Main Street Advisory Board
Agenda – June 4, 2026, 4:00 p.m.

CASE NUMBER: COA-0063-2026
APPLICANT: Crystle Leitheiser
REQUEST: Signage Internal Illumination
LOCATION: 1008 Main Street; Parcel No. 0P0030 0180000 (Washington Street Entrance)

CASE NUMBER: COA-0064-2026
APPLICANT: Robins Financial Credit Union
REQUEST: Signage Internal Illumination
LOCATION: 1008 Main St; Parcel No. 0P0030 018000 (Main Street Entrance)

CASE NUMBER: COA-0065-2026
APPLICANT: Crystle Letheiser
REQUEST: Sign Replacement with Internal Illumination
LOCATION: 1105 Main St. 0P0020 61A000 (sign on Swift St.)

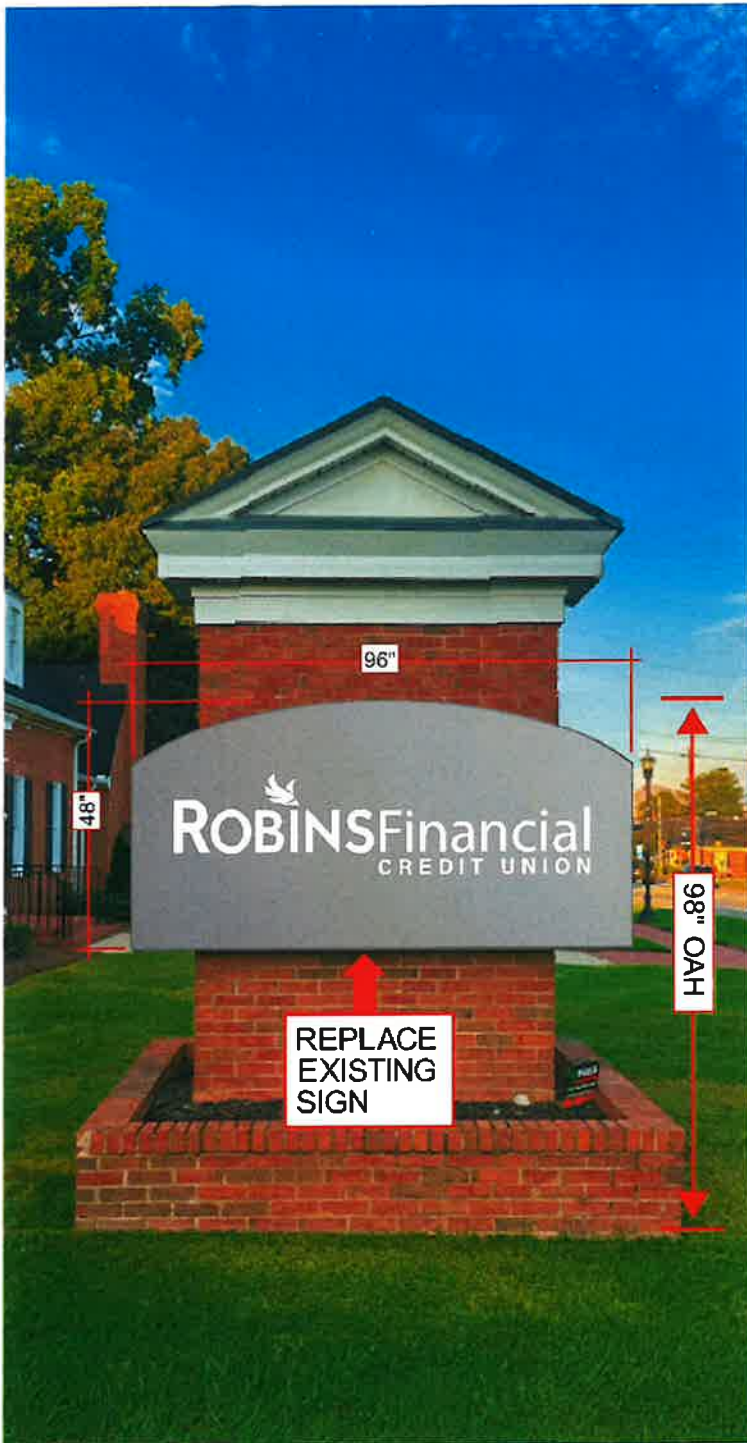
APPLICANT'S REQUEST: The applicant proposes installation of new double sided sign cabinet onto existing monument. New cabinet is proposed to be 8"x 4". The new cabinet is requested to be internally illuminated as is consistent with the current sign cabinet.

STAFF COMMENTS: The applicant has provided sketches of the proposed sign cabinet demonstrating desire to replace with new branding/logos. The requested sign cabinet replacement would be internally illuminated. The applicant's request as part of this application is only relevant to the internal illumination. All other sign standards will be reviewed through the standard sign permitting process.

STAFF RECOMMENDATION: Staff recommends approval of the application, relative to internal illumination.

* sign
on Swift St
side

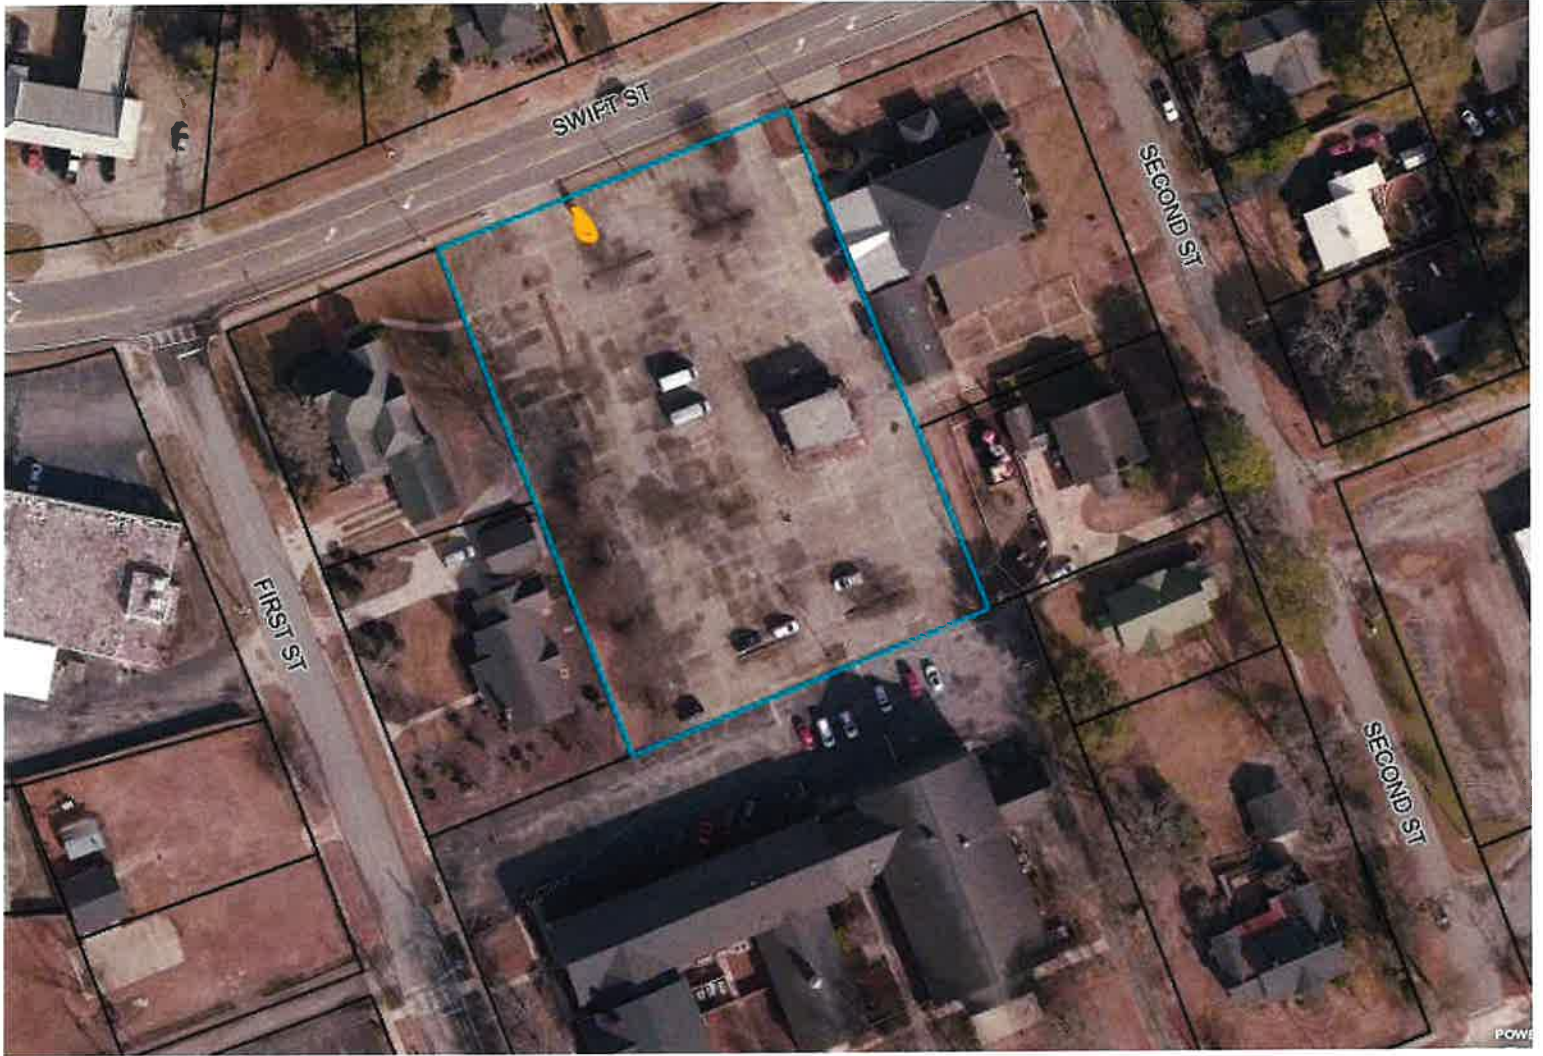
APPLICANT'S REQUEST: The applicant proposes to replace the existing electronic message board with an internally illuminated set of channel letters and cloud sign on solid background.

STAFF COMMENTS: The applicant has provided sketches of the proposed sign. In the Downtown Development District, a ground sign can only be illuminated externally. The previous sign on the property was an LED message board with internal illumination. Due to the less intense electrification of a channel letter sign than an LED message board, it is staff's opinion that the proposed sign, although internally illuminated, would provide less impact on surrounding properties. While this proposal is not requesting a "same for same" replacement, the request is for less intense illumination on a previously internally lit sign.

STAFF RECOMMENDATION: Staff recommends approval.
